SUBJECT: MAGNETO LEAD ISOLATION AND ROUTING

MODELS AFFECTED: All Models

Magneto Lead ("P" Lead) Isolation and Protection Procedure

(FIGURE 1.)

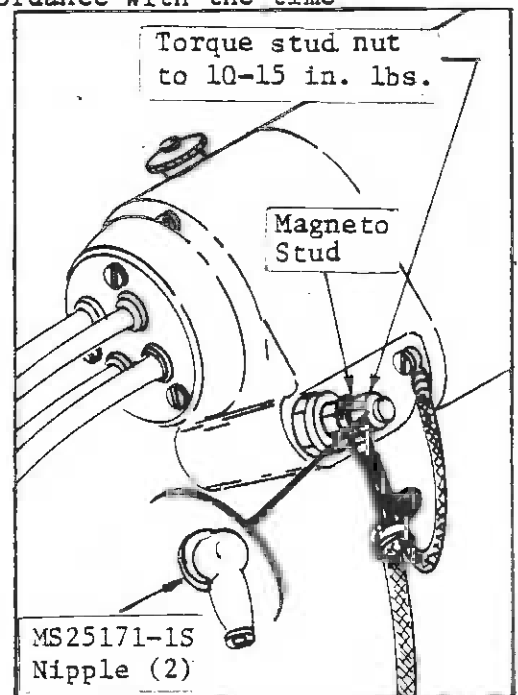
It has been reported that during a routine inspection, the "P" lead shielding, which is attached to the magneto housing, was found improperly routed and insulated which provides the possibility for it to contact the magneto stud causing a dead magneto.

1. Generally inspect the condition and security of the "P" lead and ground shielding.
- Be certain the nipple (Part No. MS25171-1S) is in place over the magneto stud and the shrink tubing is in place on the "P" lead over the point where the shielding is pulled back.
3. The "P" lead must be in a position that causes the shielding to be routed around the magneto stud instead of across the top.
 4. The shielding pigtail on the magneto lead must be pulled back, looped and secured in place with a tywrap (Part No. SST-2M) or equivalent. The loop must be outside the nipple.
